High Speed Rail in the Chilterns

Part 2: Chiltern Long Tunnel Proposal

June 2015

This document was prepared by HS2 Ltd in May 2015 for internal use, and has been published to allow petitioners to better understand the Promoter's assessment of various tunnel options.

Figure 3.1 Extracted from PBA Report

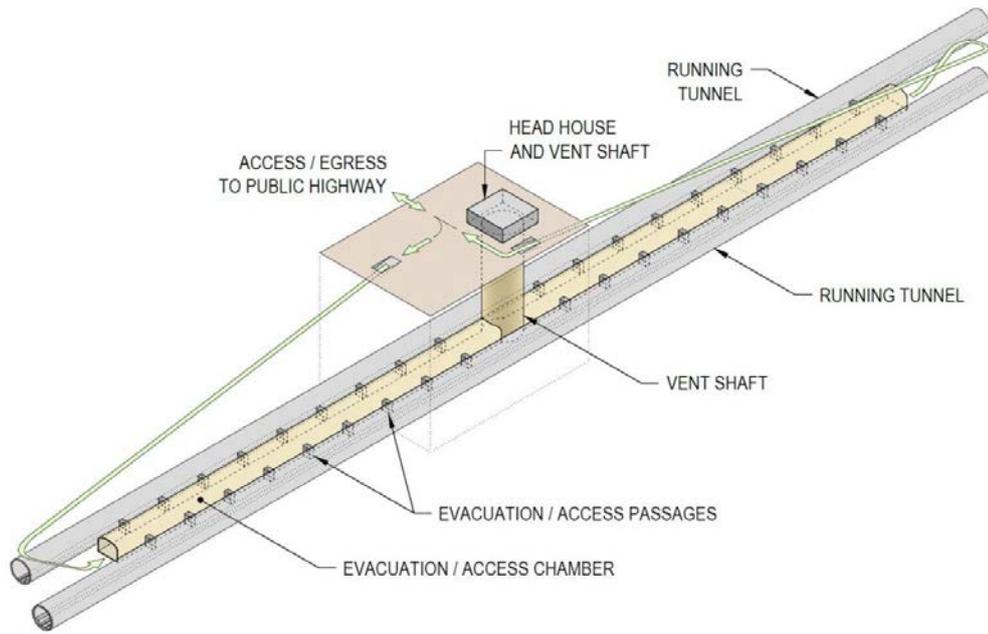
- 3.2.3 The viability of the proposed CLT is dependent on the feasibility of the FFP at the Little Missenden Shaft. The proposal envisages access roads capable of providing emergency vehicles access to rail level. These roads would be a combination of surface and underground roads that would slope down to the rail level approximately 40 to 50m below ground surface. See figures below.

- 3.2.4 The PBA proposal indicates a ramp/access road that turns back on itself and crosses over the tunnel. Assuming a maximum gradient of 1:8 the length of ramp to track surface would be approximately 400m. A typical turning radius for firefighting equipment, a pumping appliance, is generally 16.8 m and a swept circle of approximately 20m. Another geometric constraint, when considering the feasibility of the ramp from ground surface, is that the ramp would have to pass over the tunnel by at least a diameter or risk impacts requiring further measures to mitigate.

- 3.2.5 Taking into account these geometric constraints, the emergency access ramp would have to rise from between the two tunnels about 150m before turning back on itself over a 17m radius curve and rising the remaining way to the surface over another 250m and there would be earthworks associated with this ramp as it descended from ground level into the service adit. This ramp would begin from the end of a proposed emergency access tunnel located between the two running tunnels. PBA indicate that this emergency access tunnel would be at least 400m long to ensure that all passengers could disembark quickly and safely off the trains to an area of safe refuge. It is required by the TSI that an additional 100m is provided to the emergency access structure. Applying all the above dimensions to the FFP concept in the PBA proposal could considerably expand the land area required to fully encompass the FFP than is shown in the sketch in the PBA report.
